UNITED STATES PATENT AND TRADEMARK OFFICE

APPLICATION NO.	FILING DATE	FIRST NAMED INVENTOR	ATTORNEY DOCKET NO.	CONFIRMATION NO.
10/760,117	01/15/2004	DayNa M. Decker	62077-00008	7349

Office Action Summary	Application No.	Applicant(s)	
	10/760,117	DECKER ET AL.	
	Examiner	Art Unit	
	CARL D. PRICE	3749

DETAILED ACTION

G. K. BRADFIELD.
LAMP.
APPLICATION FILED APR. 20, 1913.
1,050,913. Patented Jan. 21, 1913.

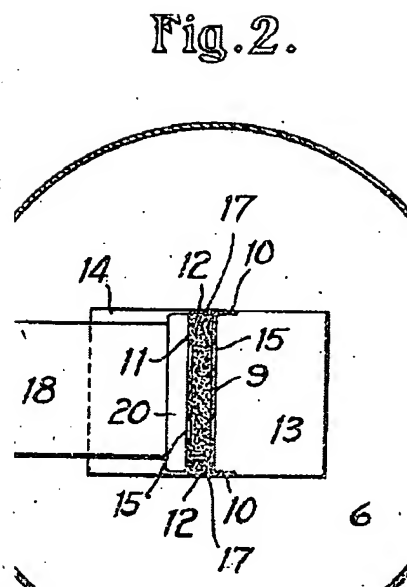
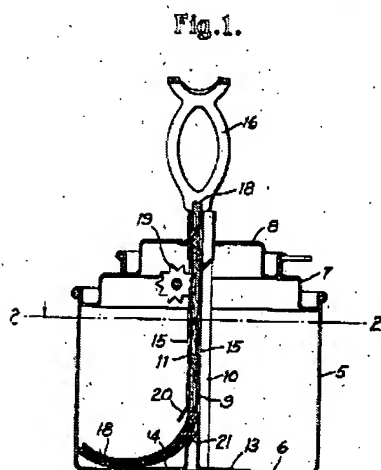
Claims **24**, **32**, **33**, **41** and **45** are rejected under 35 U.S.C. 102(b) as being anticipated by **US001050913 (Bradfield)**.

US001050913 (Bradfield) shows an apparatus including:

- a body defining a chamber for carrying a combustible liquid and having an open upper end;
- first and second plates (9, 11) arranged in a spaced, confronting relationship with lower portions located within the chamber of the body and upper portions; and

- a sheet wick (18) sandwiched between the first and second plates and having a lower end located in the chamber of the body, for contacting the combustible liquid,, and an upper end projecting upwardly from the upper portions of the first and second plates;

- further comprising a plurality of clips (12) positioned on side edges of the first and second plates to sandwich the sheet wick between the plates;
- wherein at least one of the clips (12) has a top portion (15) extending above and curved over the upper portion of the wick, side flanges (12) configured to hold the first and second plates and the wick together, and a bottom portion positioned in the

chamber of the body.
